# UNITED STATES PATENT AND TRADEMARK OFFICE

10/533,901

<b>Office Action Summary</b>	<b>Application No.</b> 10/533,901	<b>Applicant(s)</b> YOKOI, TARO	
	<b>Examiner</b> Raymond Alejandro	<b>Art Unit</b> 1795

The present application is geared towards a fuel cell system wherein the disclosed inventive concept comprises the specific configuration of the hydrogen purging mechanism.

Fig. 1

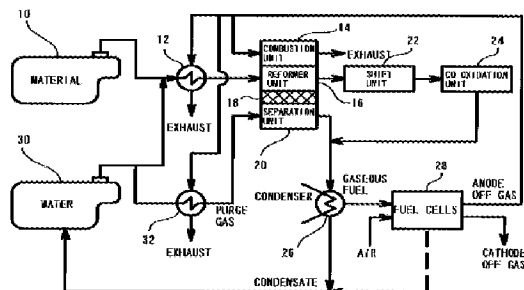
Aoyama et al disclose a fuel cell system (TITLE/FIGURE 1) comprising a fuel cell 28 that generate an electromotive force through electrochemical reactions of hydrogen with oxygen (P0098); hydrogen supplying device (material reservoir) 10 (P0098); there is implicitly disclosed the presence of a temperature adjustment mechanism and a heat exchanger as Aoyama et al teach that the temperature of the fuel gas is thus lowered by a heat exchange unit (P0044). Further, Aoyama et al disclose a combustion unit 14 or 23 to supply heat generated therein for the system (P0101 & 0142). (*emphasis added*→) Additionally, shift unit 22 and/or oxidation unit 24 might be taken as the burner in some instances. Aoyama et al also disclose the inclusion of evaporators 12 and 32 (*two additional heat exchangers*) and (P0100).

Aoyama et al also makes known a purging mechanism for purging anode off gas (the hydrogen purging mechanism) (P0186) including a changeover valve 13 provided in the flow conduit of the anode off gas to change over the working flow between the circulation of the separation unit 20 and the discharge to the outside (P0186). *It is noted that separation unit 20 is operatively connected to the combustion unit 14 (the burner). Thus, in operation combustion unit 14 is capable of discharging the generated combustion gas to a site where the heating medium is*

or is not present while anode-off gas purging takes place as instantly claimed. See conduit lines 12 and 32 (evaporators 12 and 32).

Fig. 1

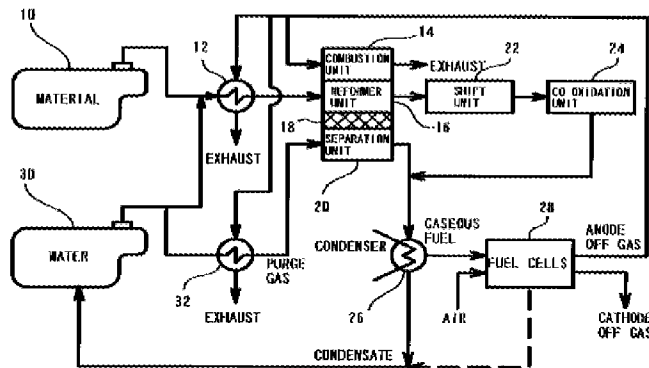
If any one of evaporator 12 and 32 is construed as a heat exchanger, then it can be said that anode off gas conduit exhausted from the fuel cell bypasses heat-exchanger 12 when it is diverted to pass through heat exchanger 32 assuming that shift unit 22 or oxidation unit 24 behaves as the burner (See **FIGURE 1**). Additionally, exhaust from oxidation unit 24 bypasses condensers 13 and 32 when it is passed through condenser 26 (See **FIGURE 1**).

*It is noted that separation unit 20 is operatively connected to the combustion unit 14 (the burner). Thus, in operation combustion unit 14 is capable of discharging the generated*

*combustion gas to a site where the heating medium is or is not present while anode-off gas purging takes place as instantly claimed. See conduit lines 12 and 32 (evaporators 12 and 32). (Emphasis added→) See inherency statement above for additional details concerning the conditional statement or proviso related to the limitation: a) "when hydrogen purging is executed..." (claim 2); b) "wherein, if the heating medium passage switching mechanism has set..." (claim 3); c) "wherein, if the heating medium passage has been set..." (claims 4-5).*
